# City of San Luis

### CITY OF SAN LUIS City Hall East Wing Remodel **Bid Addendum #1**

Date Issued: **3/13/25**

### EXHIBIT A

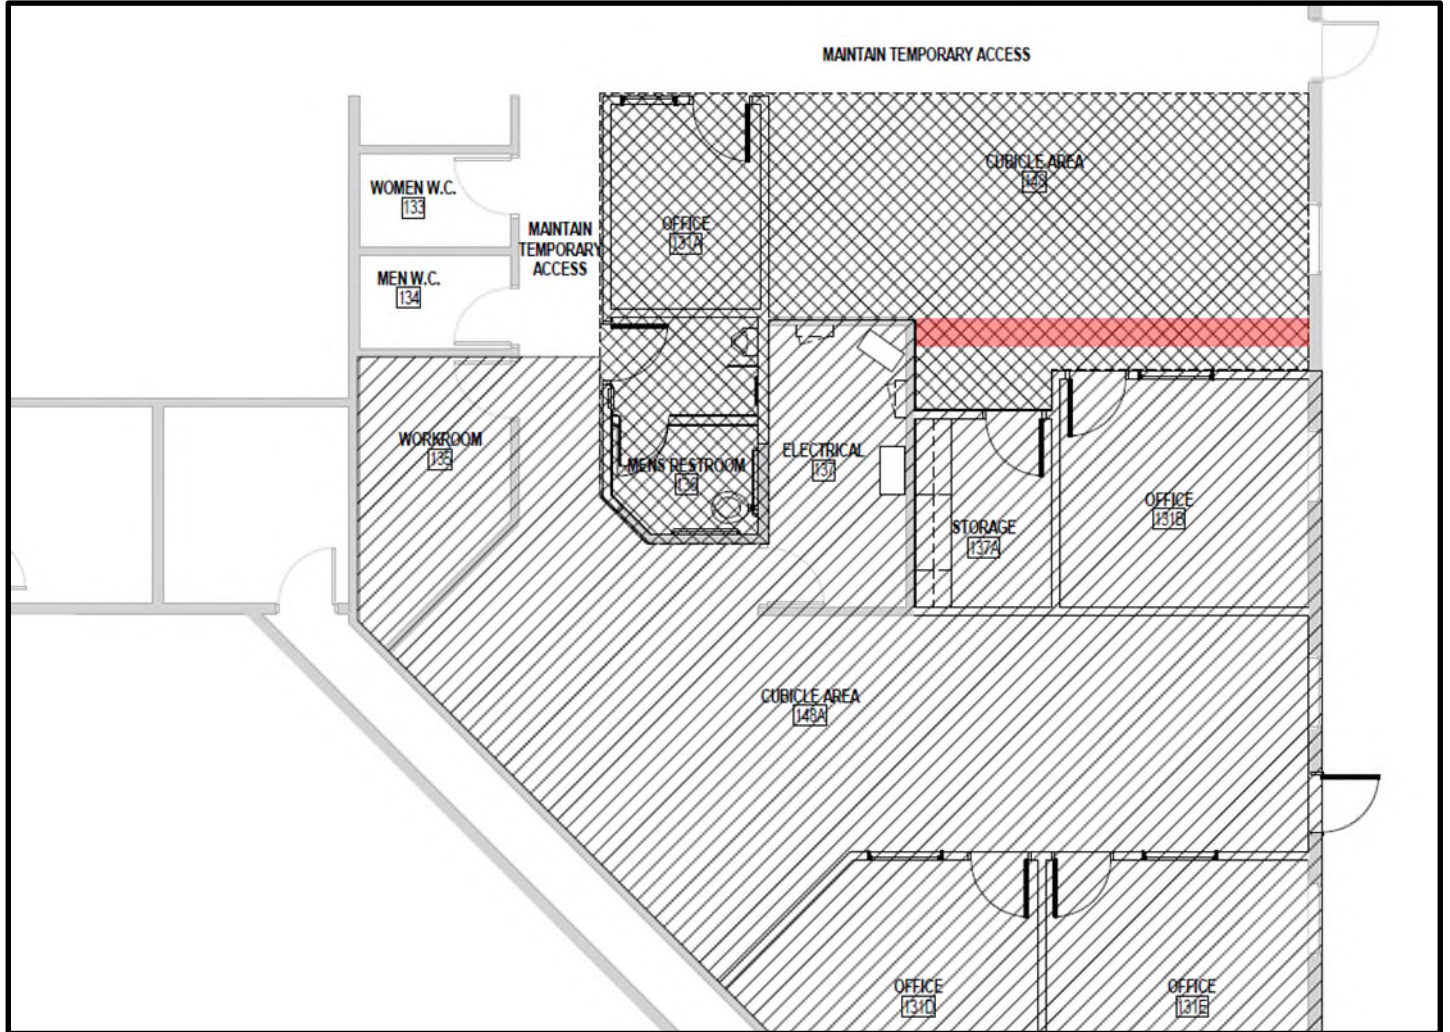
**Question 8: What location is the temporary wall going to be?**

The temporary wall location highlighted in red. 1-2 feet of playing room.

**Response 8:** Temporary wall that separates Phase 1 and Phase 2 is between cubicle area 148 and new office 131B. (See Exhibit A)
